IIoT Product Change Notice

1. Reason for the Change: MIC-75M13 and MIC-75M40 implement tooling product

2. Affected Product: MIC-75M13 and MIC-75M40. T part numbers will NOT be changed unless customer requests to do.

6. Physical Difference(s):

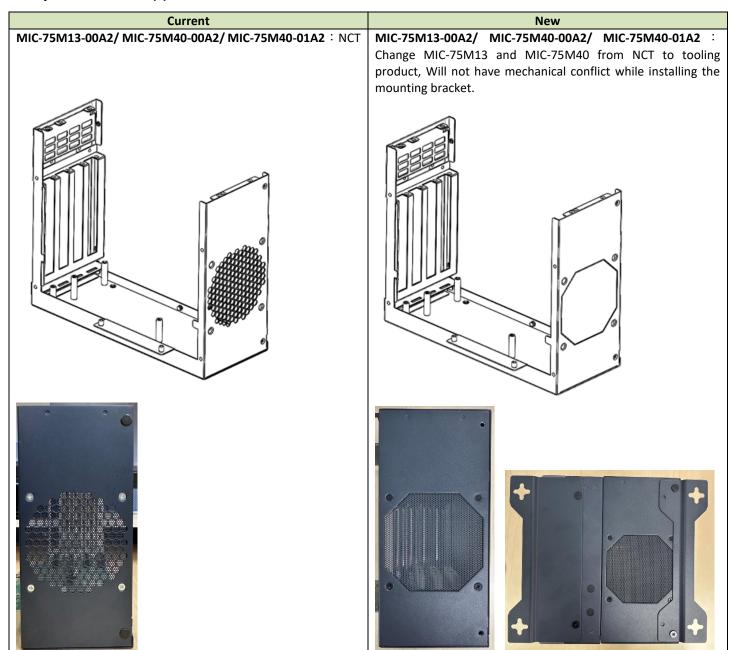
Affected Models	Current Component	New Component	Category	Outlook Difference	Reason
MIC-75M13-00A2	NCT	Tooling product	Mechanical	Yes	Implement tooling product
MIC-75M40-00A2 MIC-75M40-01A2	NCT	Tooling product	Mechanical	Yes	Implement tooling product

Affected Models	ECOM Number	Estimated Effective Date	Cut-in Implement	Change Description
MIC-75M13-00A2	ECOM-213301	2024-Apr.	Cut in from open and new work order	Change 1950018713N012 (NCT) to 1950018713T001 (Tooling)
MIC-75M40-00A2 MIC-75M40-01A2	ECOM-213301	2024-Apr.	Cut in from open and new work order	Change 1950018713N012 (NCT) to 1950018713T001 (Tooling)
